CONSTRUCTION DOCUMENTS

FALCON MARKETPLACE

ISSUE	DATE
90% SUBMITTAL	5-6-19
REVISED	7-19-19
DESIGNED BY:	TDM
DRAWN BY:	KGV
CHECKED BY:	TDM
FILE NAME:	20988-CD-CVR

COVER SHEET

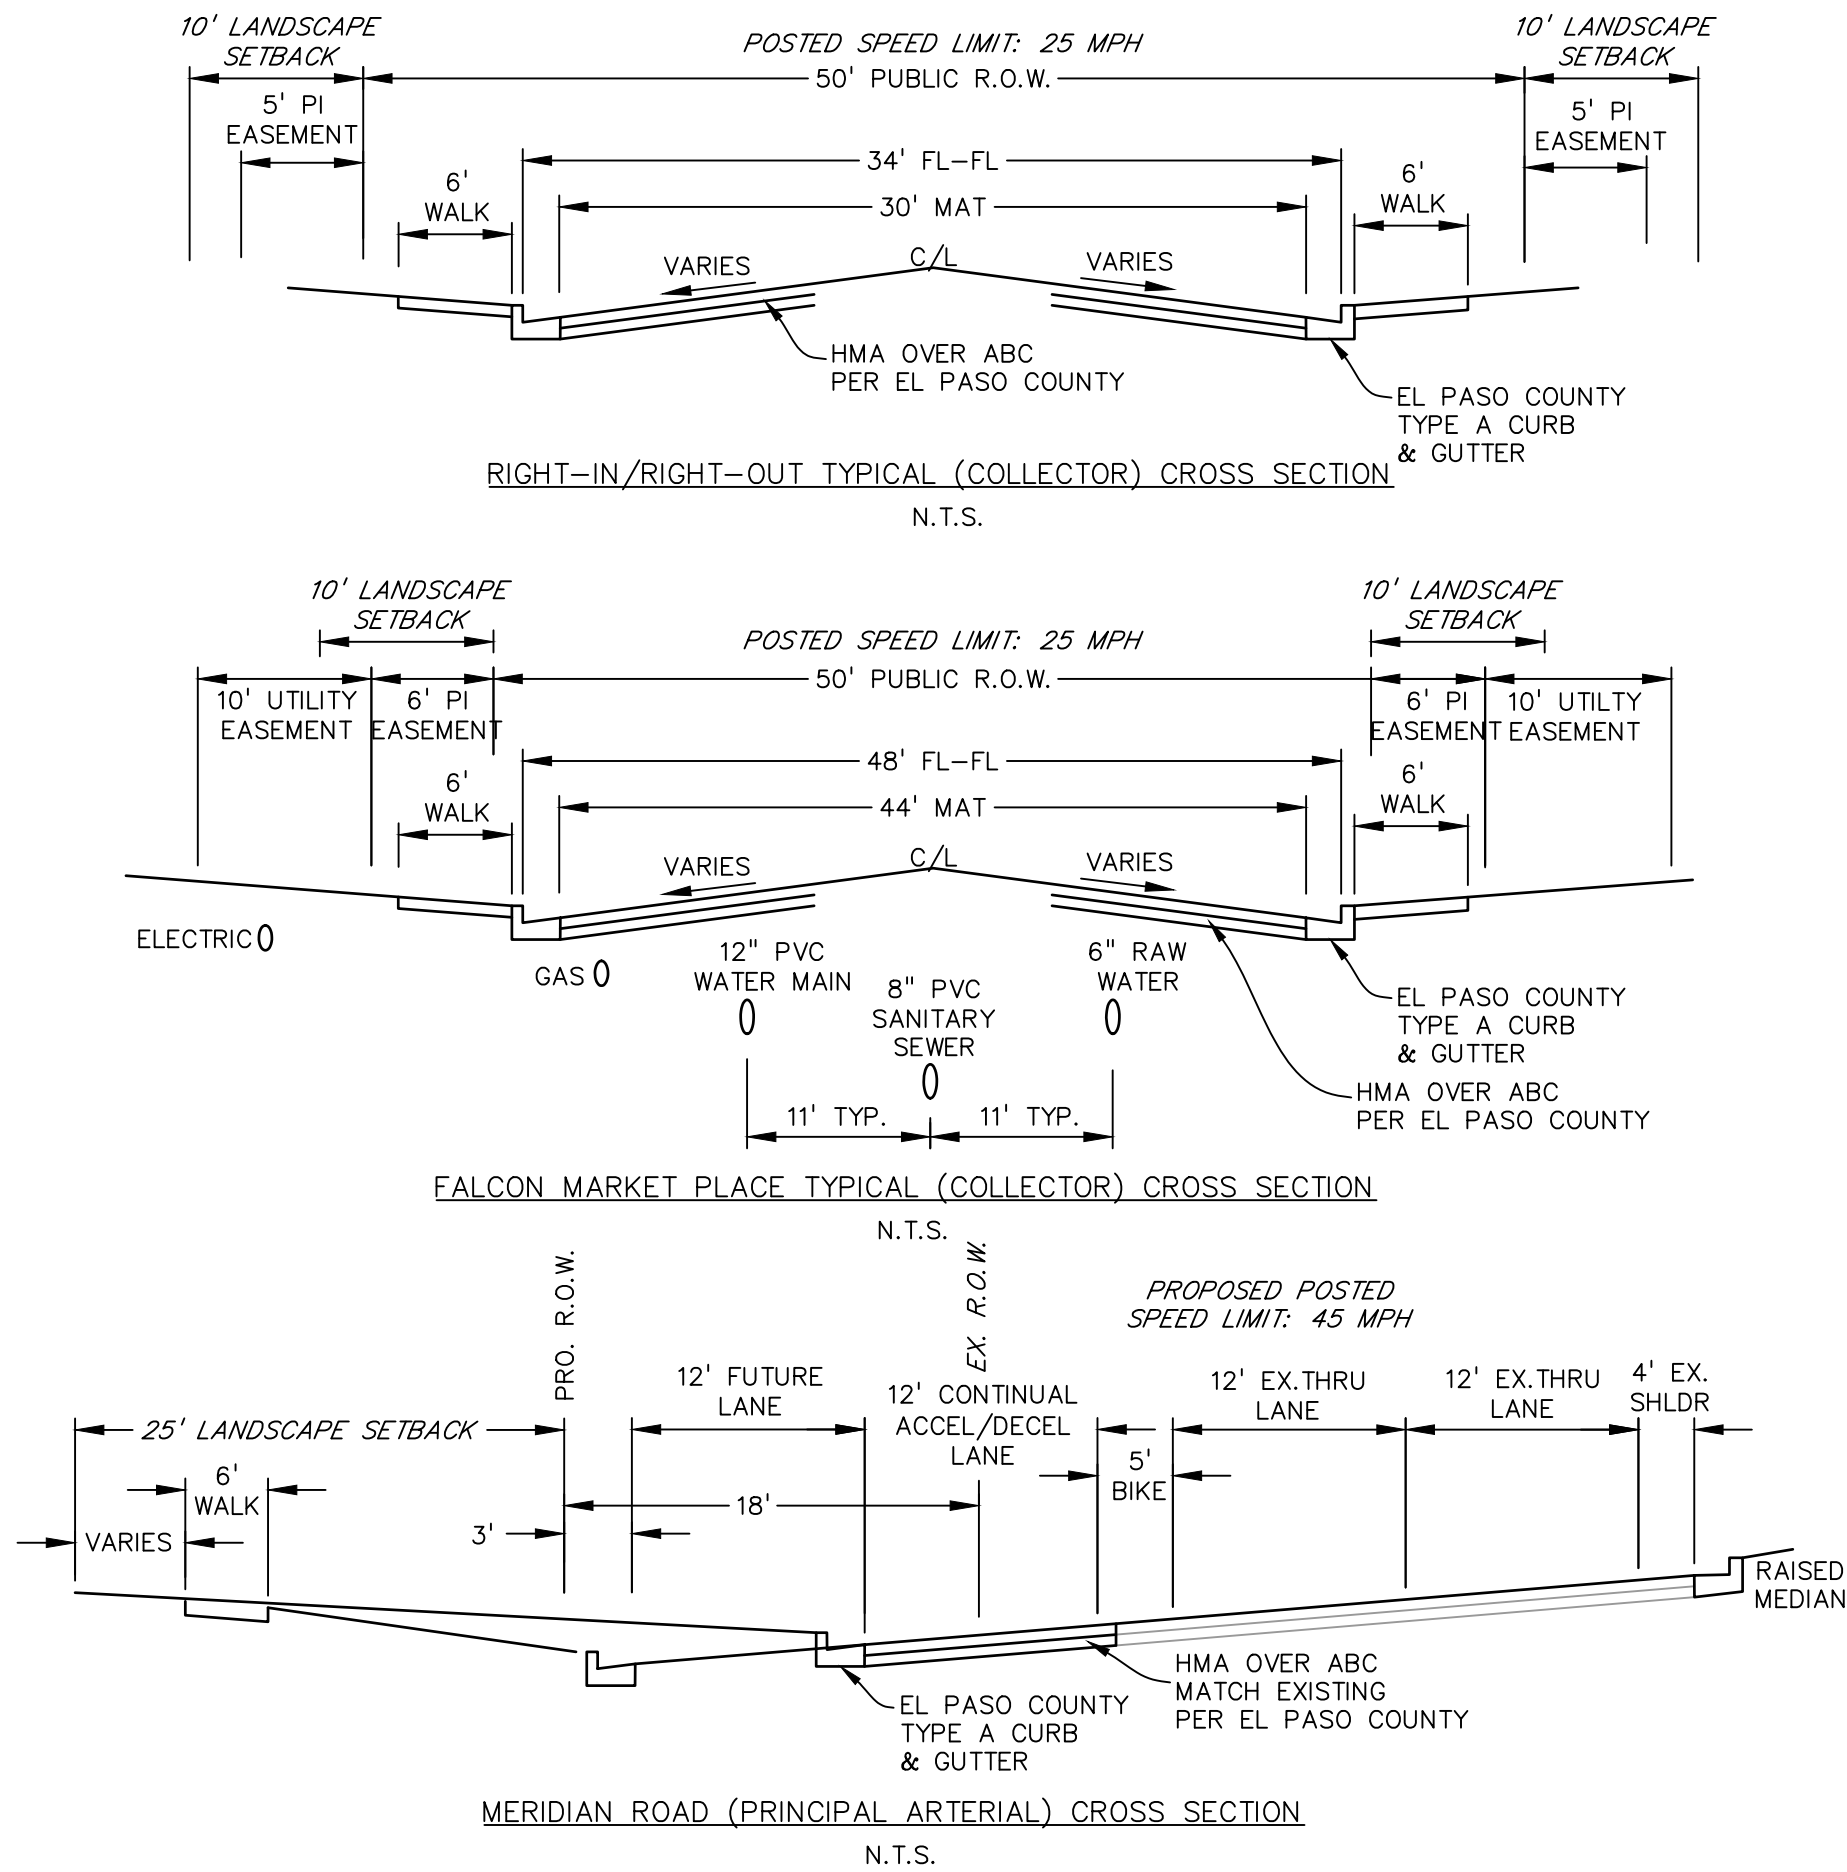
Update notes

**FALCON
MARKETPLACE
PLAN & PROFILE**

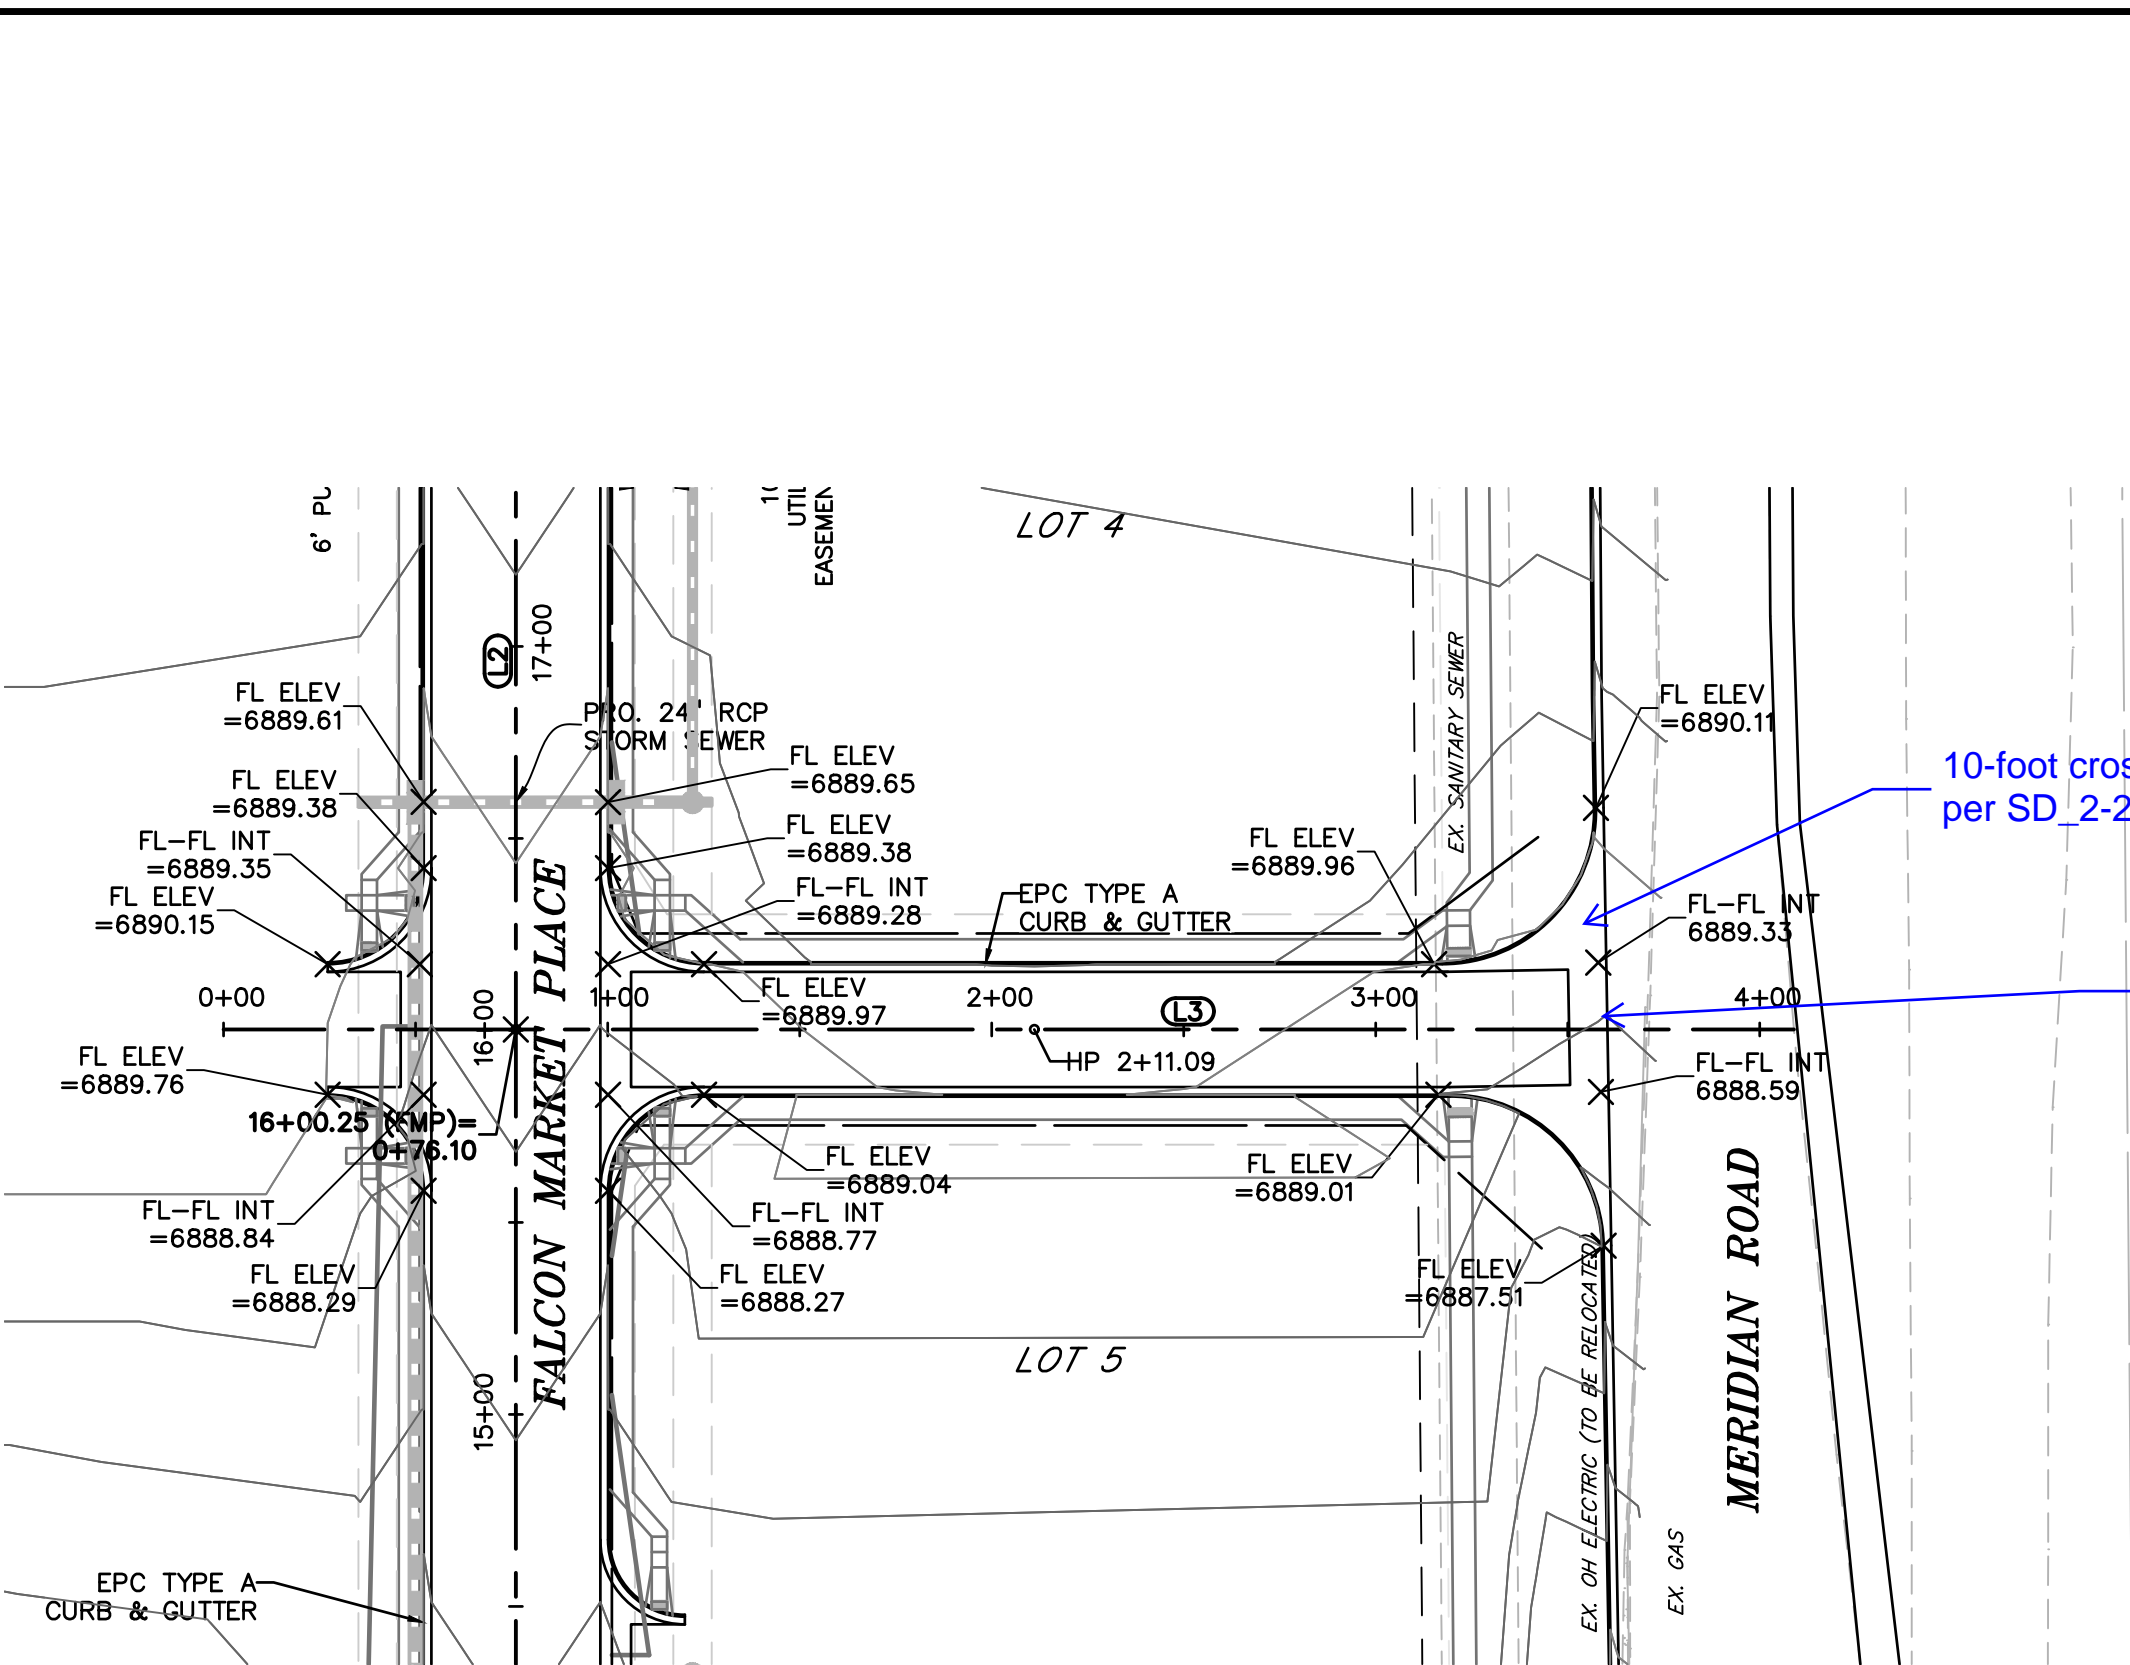
10-foot crossspan
per SD 2-26

The contour low
point and spot
elevations should
be centered in
crossspan.

TURN LANE EXTENSION PLAN

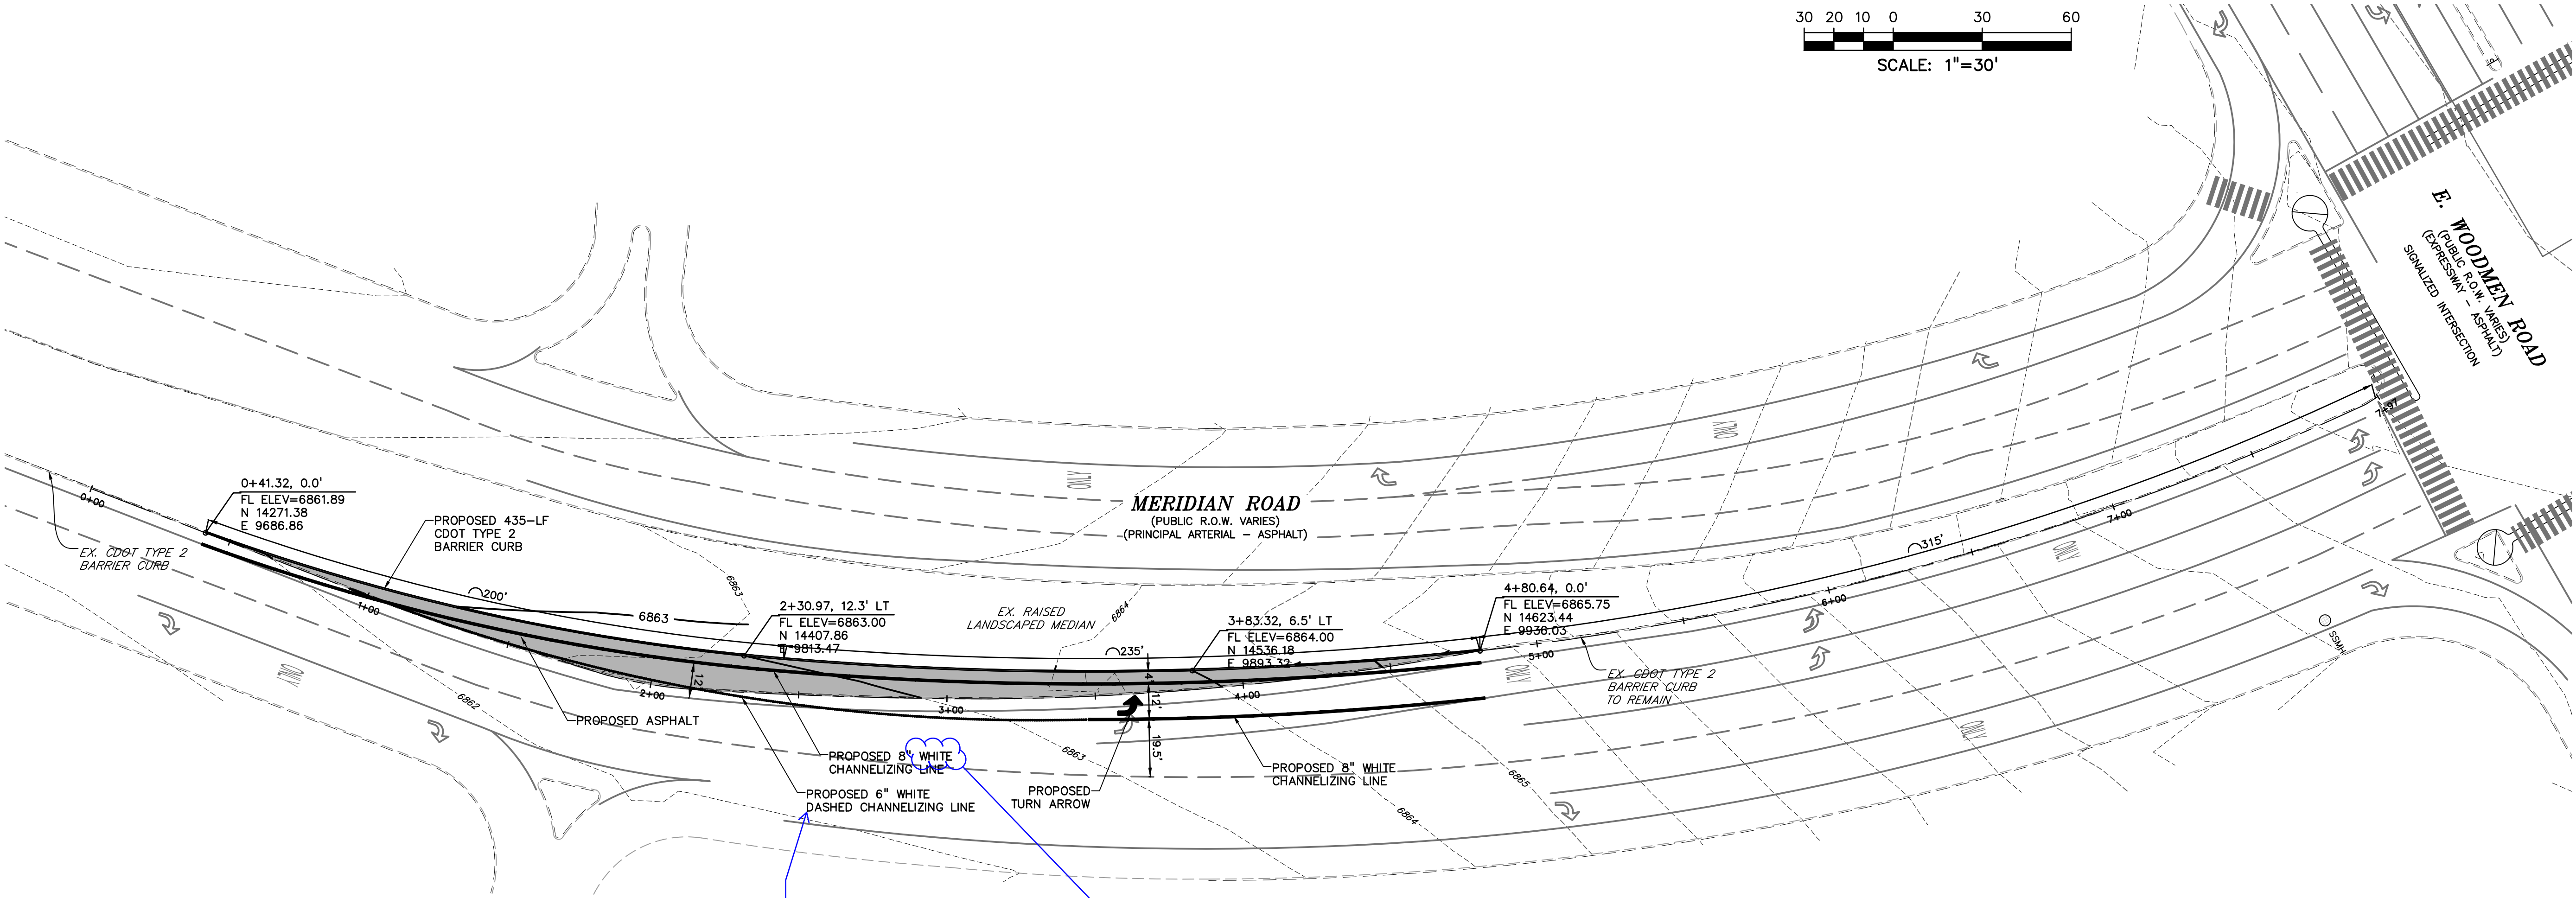
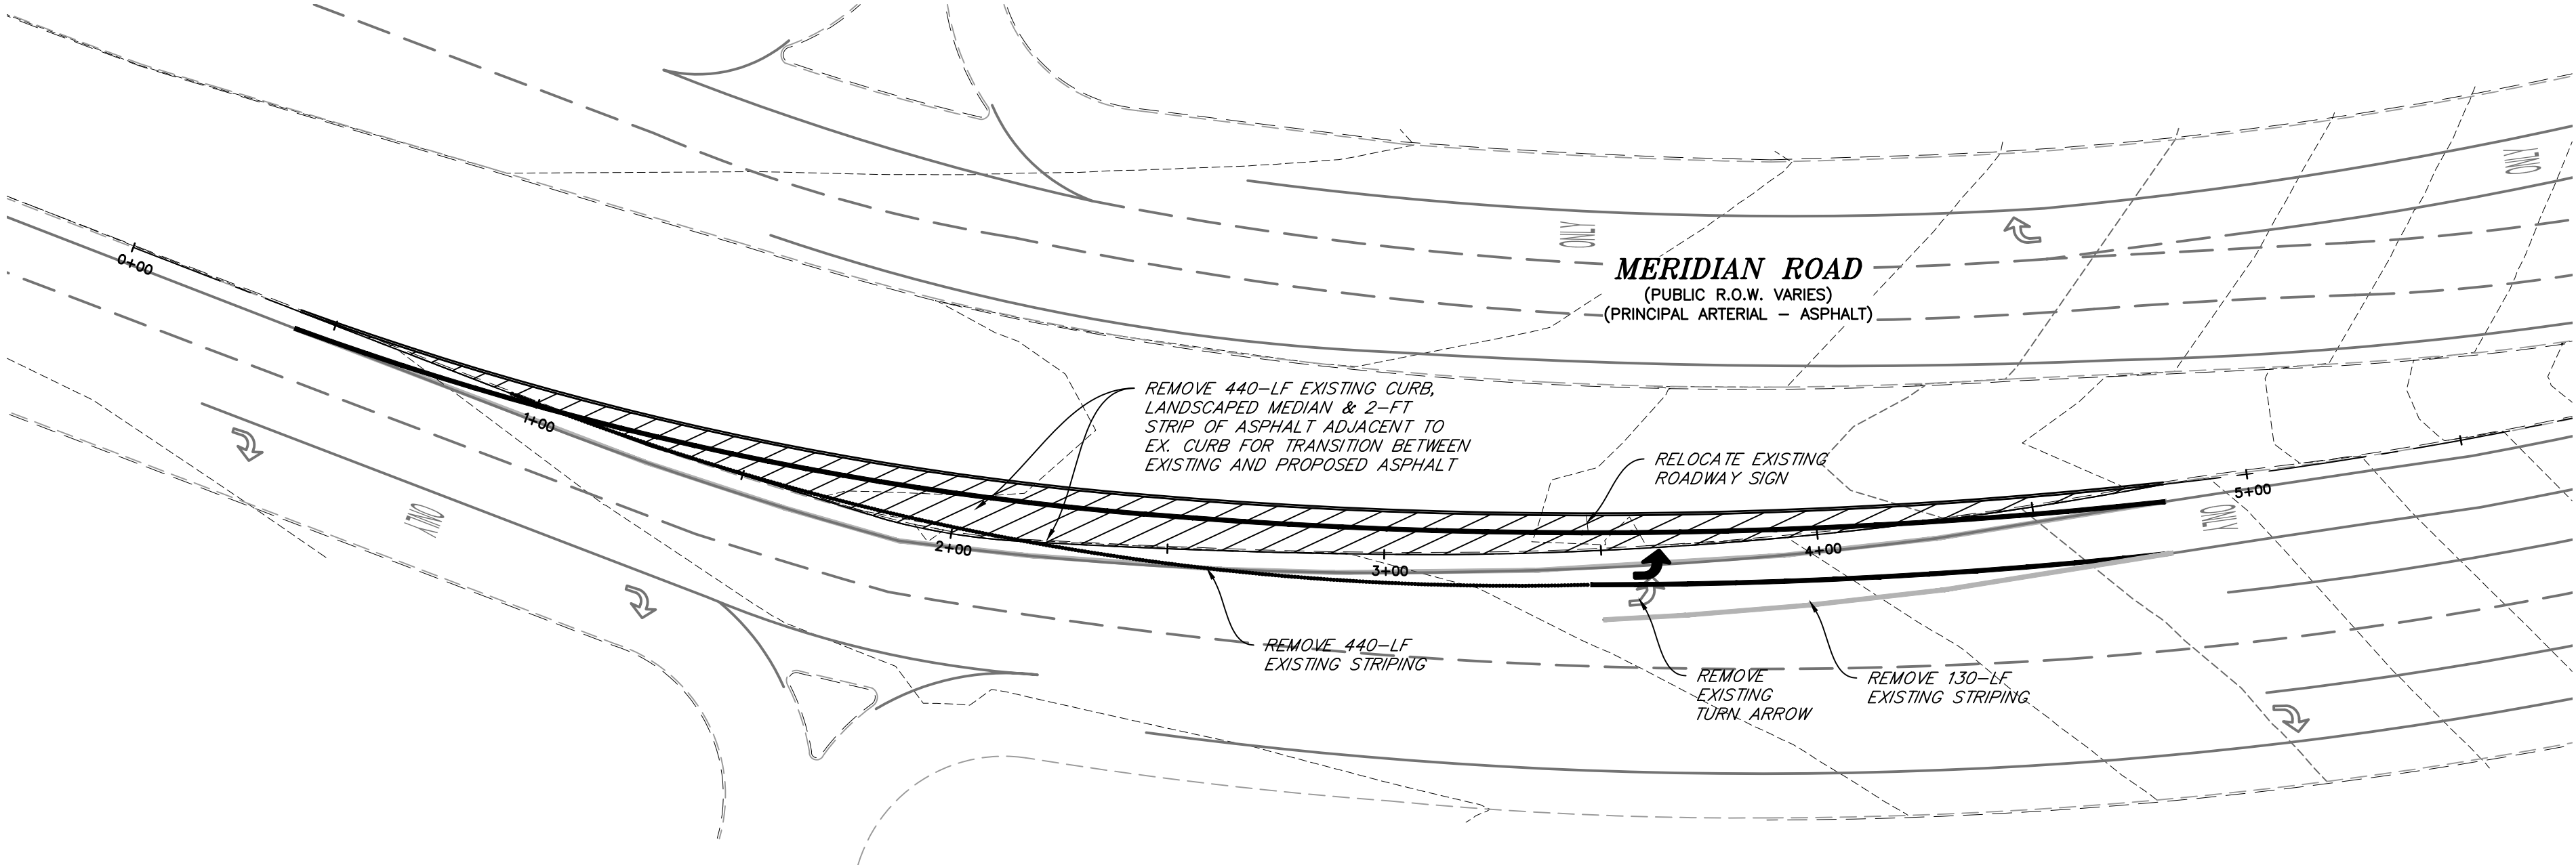
8" dotted? yellow?
